From: Rich Vincent-Barr
Sent: 21 Nov 2019 20:08:49 +1100
To: Contact Us
Subject: DA0609/2019 - 14-16 St Georges Sq, East Launceston

REF: DA0609/2019 - 14-16 St Georges Square, East Launceston

**RE: DA 0609/2019. 14-15 St Georges Square East Launceston 7250.
Residential – Construction of a dwelling**

Re: DA0609/2019 – Construction of a Dwelling 14-16 St Georges Square

Figure 1: From southern elevation

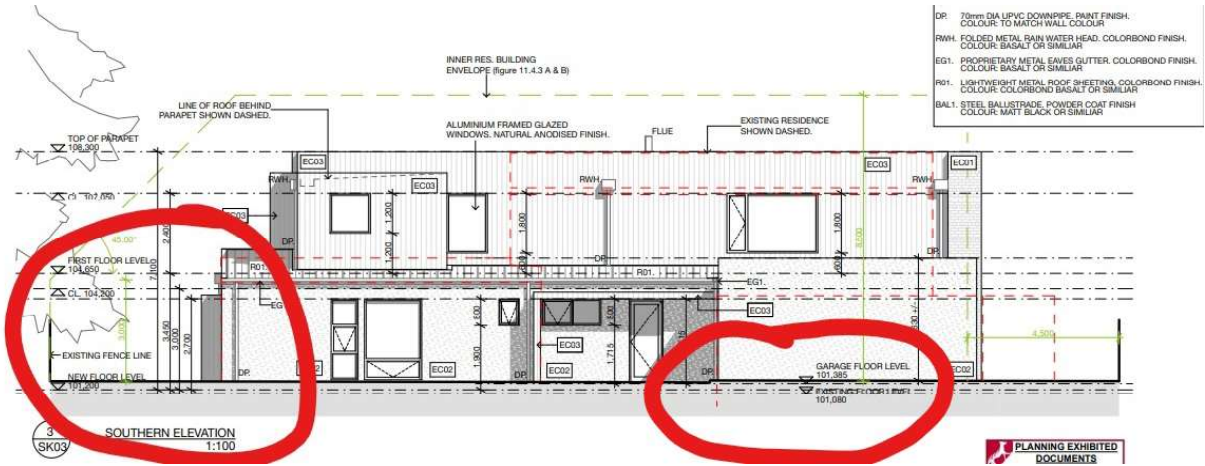
The proposed landscaping works to a depth of one-to-two-metres are indicated in the southern and western sides of the property, as these works are intended within the tree protection zone (tpz) and spz (noted in figure one below in the red circle for the southern and western elevations), such deep excavations as noted by a previous arborist report by Frank Rossol in 2015 (which the council has copies of), would compromise the sequoia trees health. The fact that a French drain and numerous concrete steps at the rear of both the western and southern sides of the site and which are within the tpz and some areas of the spz is not noted by the DA, how removal without excavators breaching the spz is required to remove the height difference of the back of the site is not noted. So it would be prudent for arborist consultation or a re-modification of the plans. An error in the DA which indicates a setback to both 54 Ann Street and 5 Scott boundaries for the new dwelling obviously needs to be corrected.

Figure 4: The ground floor plans for DA

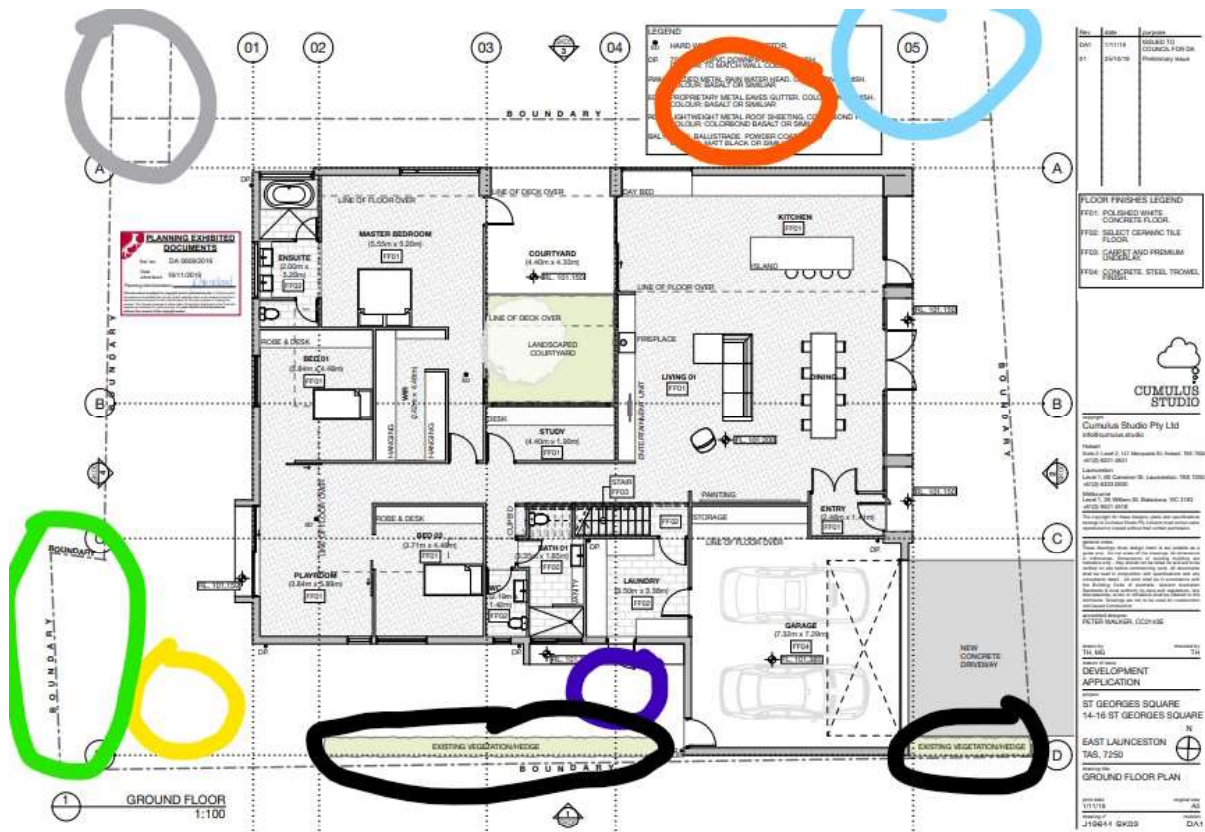
Figure four indicates that some vegetation is to be retained in the DA and these are shown (two rows of conifers circled in black), but no mention of the sequoias or other trees are shown (positions of those trees positions and their canopies are circled in the same colours used as with figure three). Some necessary two metre telecommunications and plumbing pipelines for the dwelling are circled in figure three as grey. No indication as to any distance from the sequoia trees these excavations is given; do they breach the tpz is indeterminable. Again a arborist report/consultation should be provided to the council to ensure that no unnecessary errors are made in the requisite excavations for the slab and essential piping.
